## Haggerty Road Development SP 07-22A

Consideration of the request of ACR Investments, LLC, for Preliminary Site Plan and Storm Water Management Plan approval. The subject property is located in Section 36, east of Haggerty Road, north of Eight Mile Road, in the B-3, General Business District. The subject property is approximately 0.48 acres and the applicant is proposing the construction of an approximately 2,575 sq. ft. single story office building.

## PLAN REVIEW CENTER REPORT

Haggerty Road Development PRO  
SP #07-22A

**REDUCED SITE PLAN**

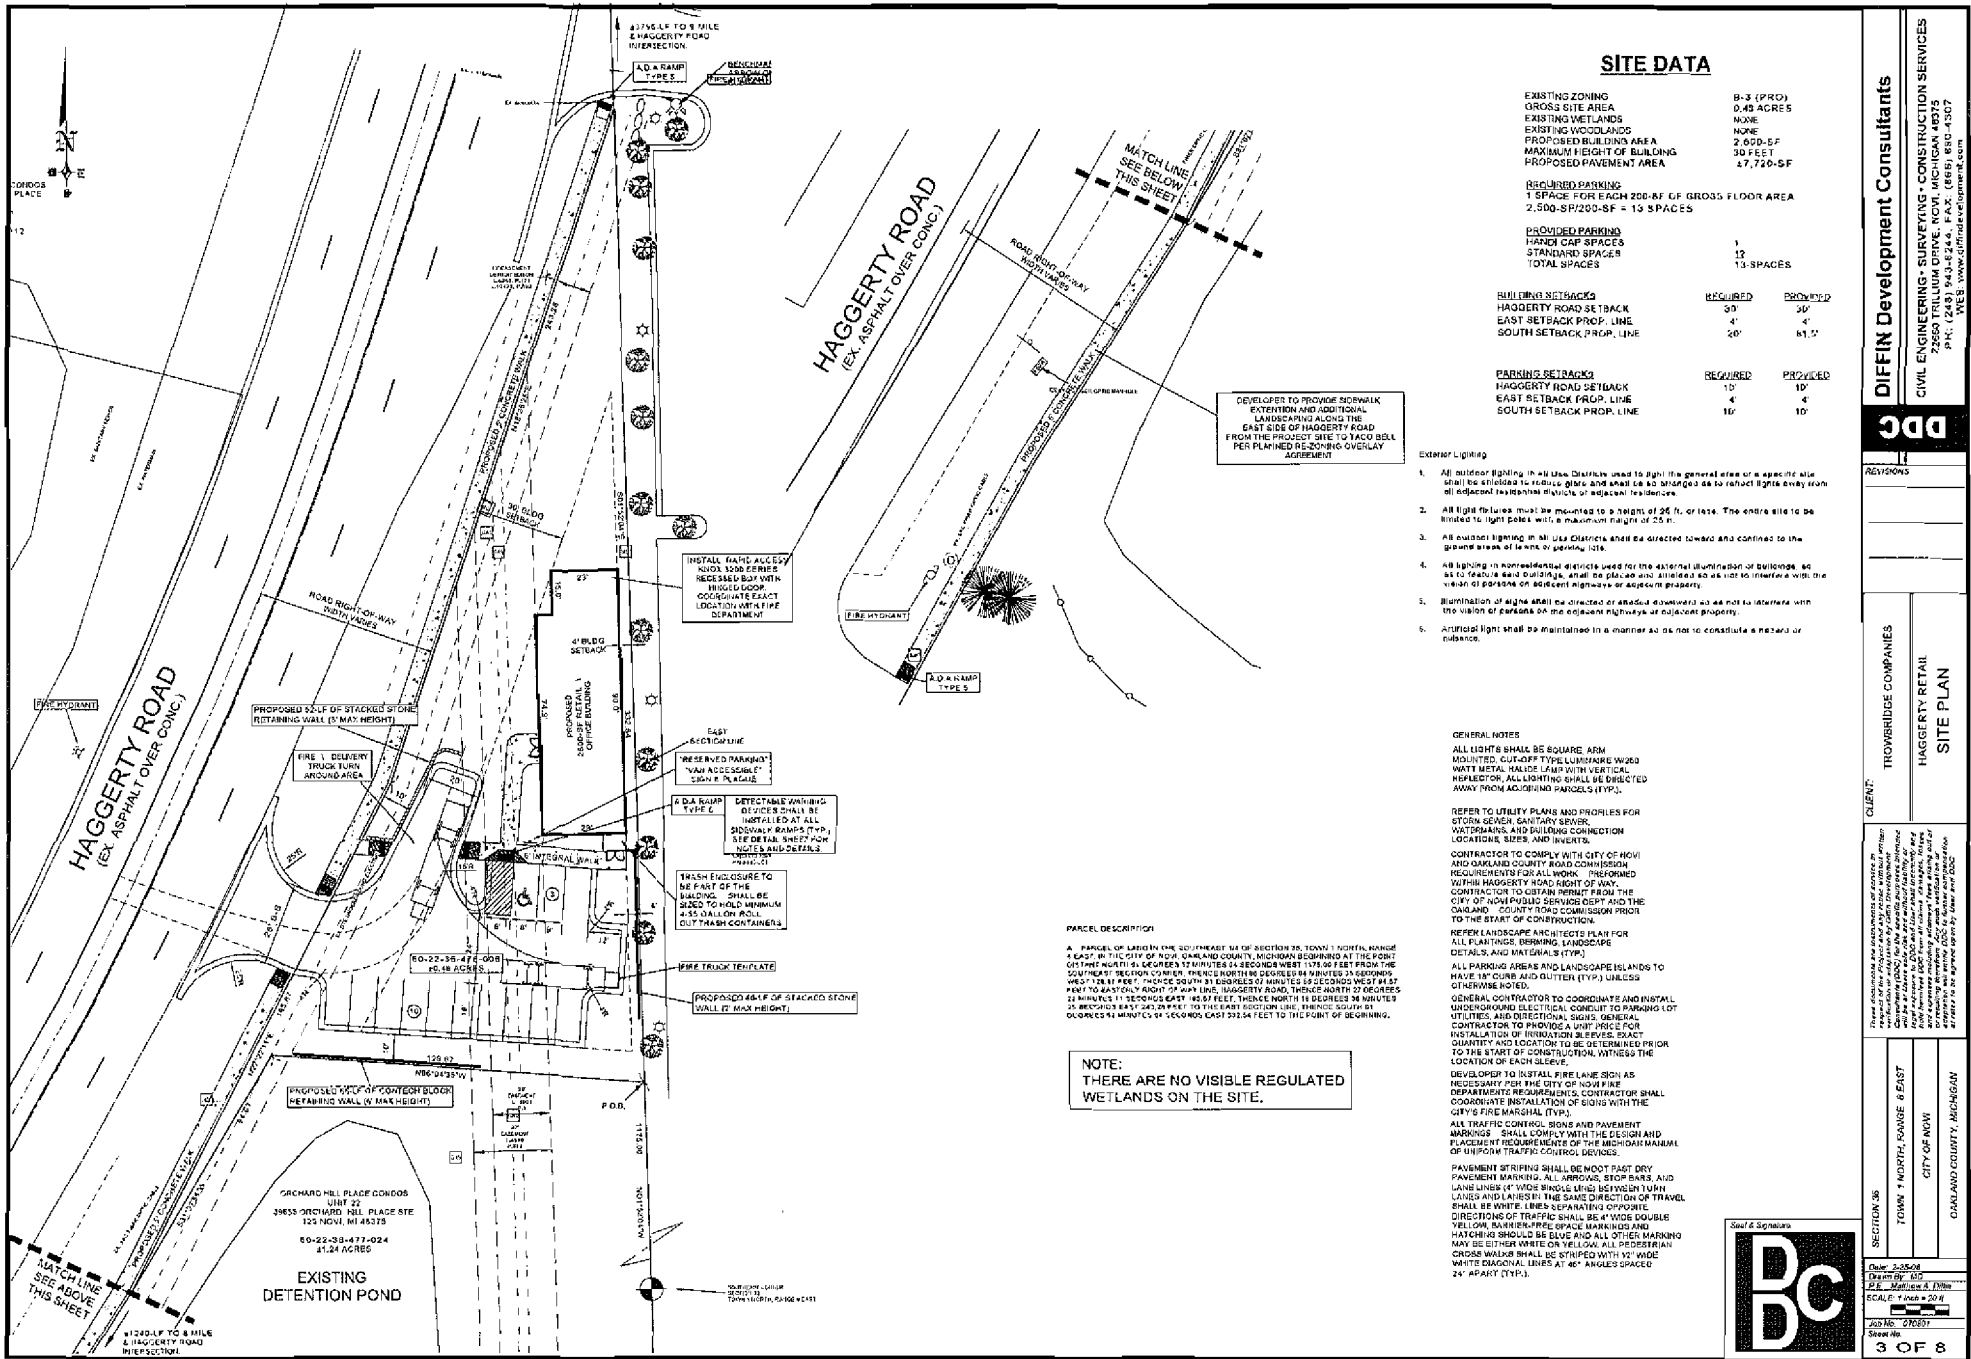
1. Accessible Parking: The plans indicate an 8' wide van-accessible aisle to the west of the proposed van-accessible handicap parking stall. Since most handicap-accessible vans feature the lift on the passenger side, the aisle should be located on the east side of the accessible parking space.

2. Parking Stall Length: In the current configuration, a vehicle bumper that overhangs the sidewalk would reduce the width to only 4'. In order to provide usable sidewalk width of 5', the sidewalk width should be increased to 7', while the parking stall length may be reduced to 17'. This allows for a 2' bumper overhang.

Additionally, the architectural plans indicate another exterior door near the northwest corner of the building. Sidewalk should be provided in front of this door and should be extended along the front of the building, so as to provide access to the parking lot.

4. ADA Ramps: The nomenclature of the ADA ramps indicated on the plans is obsolete. The most recent nomenclature per current MDOT details shall be provided. Type P Parallel Sidewalk Ramps (per the MDOT Standard Detail for Sidewalk Ramps, R-28-F) should also be provided at the handicap parking stall, so that an accessible walkway is maintained.

5. Retaining Wall: The details for the retaining walls indicated on the site plan should be provided.
6. Traffic Signs: Subsequent plan submittals should show the location of all proposed traffic signs and pavement markings. Proposed signs and markings should indicate a parking prohibition in both turnaround areas. Additionally, a traffic sign quantity table (including a brief description, side codes, and sign dimensions) should be provided on the plans.
7. Driveway Width: Per City of Novi standards, the driveway throat width should be widened to 30' (measured to back of curb). The plans currently call for a 28'-wide driveway.
